Appendix 4.2 G
Correspondence with KCC Roads Department

Title: **Stage 1 ROAD SAFETY AUDIT**

Proposed Data Centre R409, Naas, Co. Kildare

Report reference: **1918R01**

Drawing 2232-DOB-ZZ-ZZ-Dr-C-1600, R409

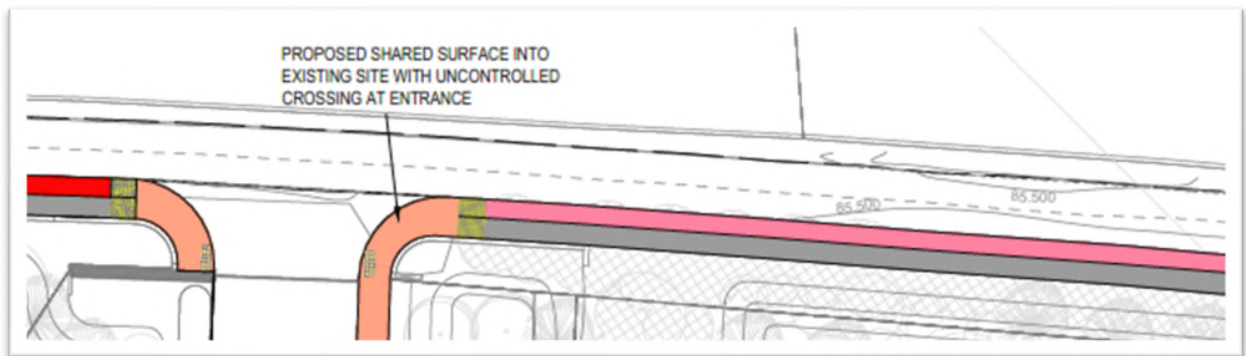
It is proposed to provide a cycle track to the proposed development and beyond in the northbound direction. It is not however proposed to provide cycling facilities for those returning from the development to Naas in the southbound direction. A lack of segregated facilities in the southbound direction will lead to less protection for cyclists from general traffic.

Drawing 2232-DOB-ZZ-ZZ-Dr-C-1600, R409, Existing Safety Barriers.

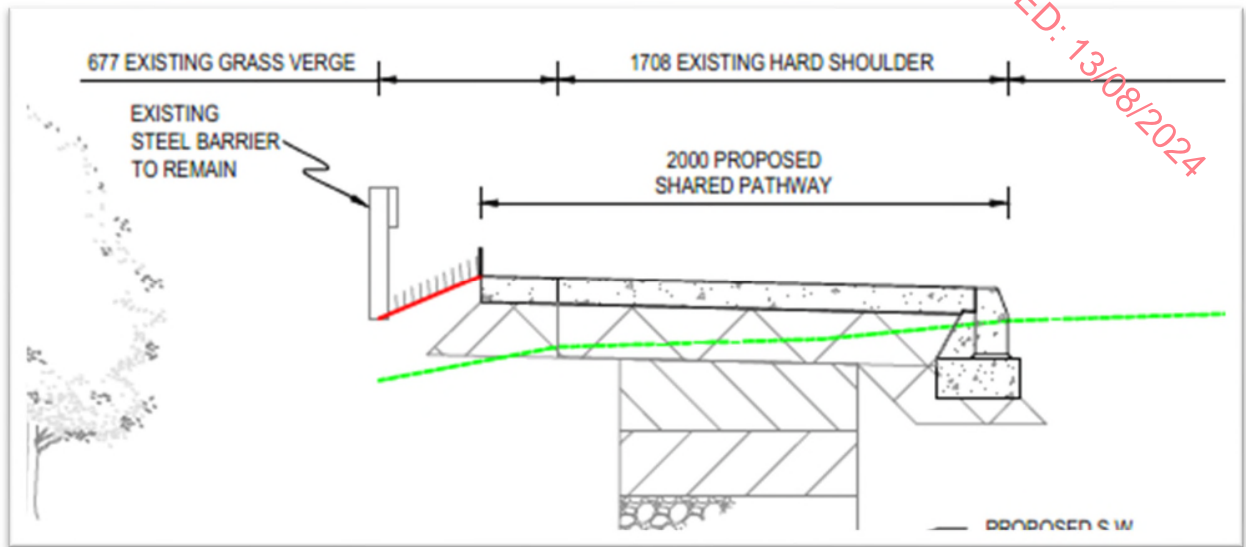
There are approach and departure safety barriers at the structure protecting errant vehicles from the high embankments and motorway below. With the provision of a kerbed edge and paved surface above the existing level the barriers may no longer contain errant vehicles if they are too low. It is also observed during the site visit that the safety barriers may not be EN1317 compliant.

Drawing 2232-DOB-ZZ-ZZ-Dr-C-1600, R409, Existing Parapet upstand.

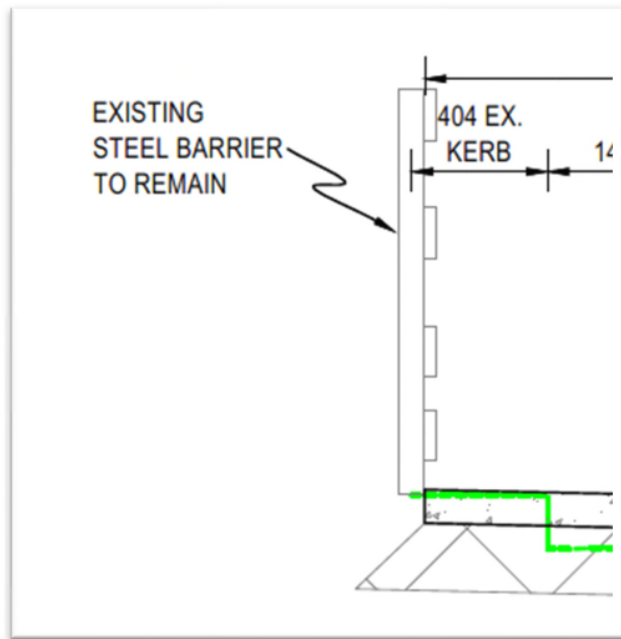
It is unclear if the existing parapet on the M7 overbridge will function as intended if struck by a HGV if there is no concrete upstand. A lack of containment could lead to vehicles descending onto the motorway below.

Drawing 2232-DOB-ZZ-ZZ-Dr-C-1600, R409, Bus Layby.

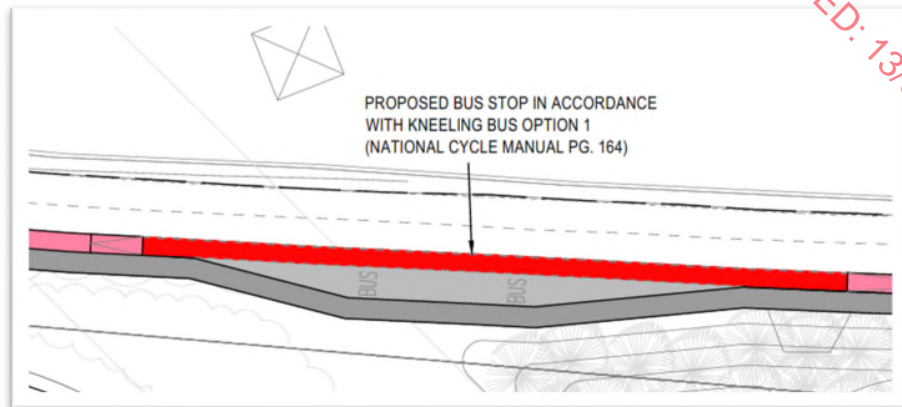
It is proposed to provide a bus layby that will presumably serve both the proposed development and the Oberstown Industrial Park. No provision has been made for crossing bus users or those getting the return bus to Naas. A lack of crossing facilities could lead to pedestrians stepping out from in front of or behind parked buses leading to collisions with through traffic.

Drawing 2232-DOB-ZZ-ZZ-Dr-C-1600, R409, New access junction.

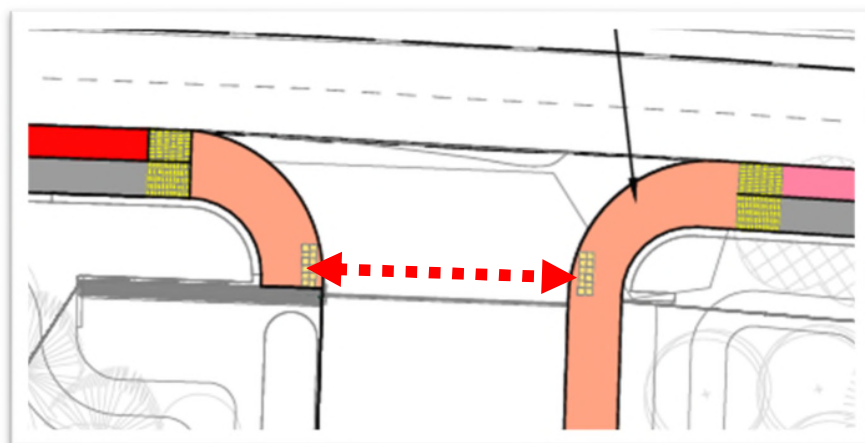
The crossing point at the proposed access junction for cyclists and pedestrians is set back from the through route, is narrow for both users and may be close to the gate which could obscure an exiting driver's visibility to those crossing vulnerable road users. This could lead to collisions between cyclists and pedestrians as they share space, collisions with exiting vehicles or lack of use of the cycle track as cyclists see the crossing as being too far off the desire line and opt to remain on the carriageway instead.

Drawing 2232-DOB-ZZ-ZZ-Dr-C-1600, R409, New access junction.

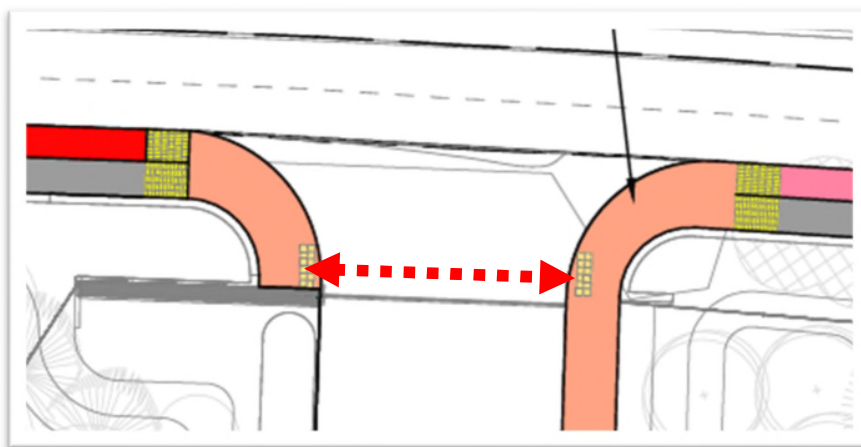
The main access junction has a wide cross sectional width due to the splitter island and need to cater for HGVs. This will lead to high turning speeds for smaller vehicles and thereby increase the risk of collisions with crossing pedestrians and cyclists.

It is recommended that a raised table be provided to cater for crossing pedestrians and cyclists.

Drawing SES 04723 Issue 1, Public Lighting.

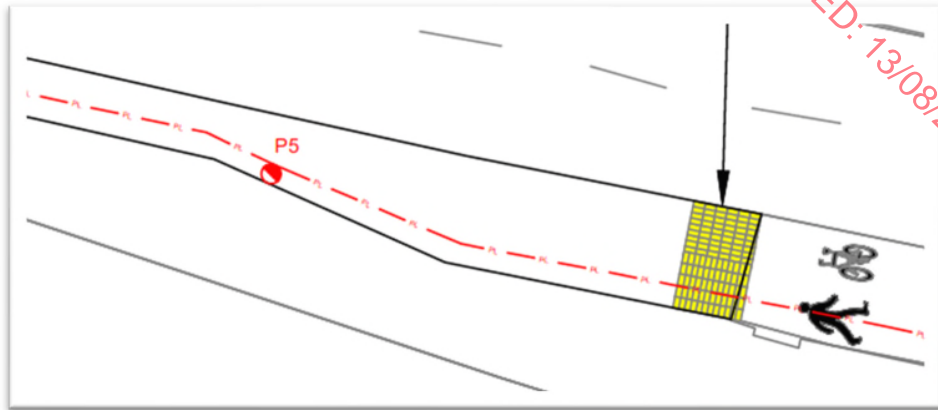
It is proposed to provide the public lighting columns within the new and existing footpaths. The columns could be hazards for pedestrians if they are looking down and are distracted and the columns also reduce the effective width of the footpath.

It is recommended that the columns be set back off the footpaths into the verge behind.

Drawing SES 04723 Issue 1, Public Lighting.

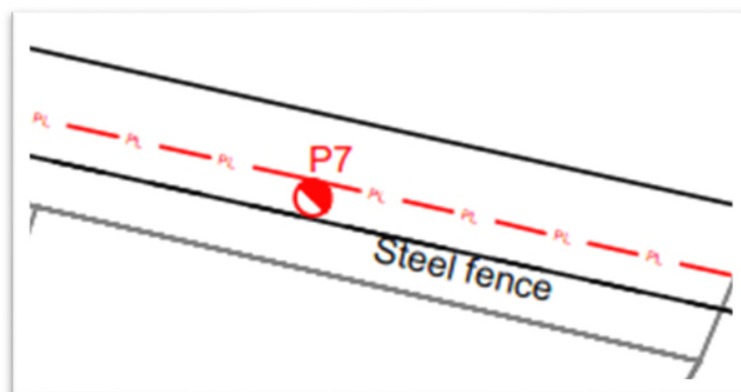
It is proposed to provide the public lighting columns in front of the safety barrier on the R409. Vehicles that collide with the barrier may be directed into the columns rather than be redirected into the carriageway resulting in more severe collisions.
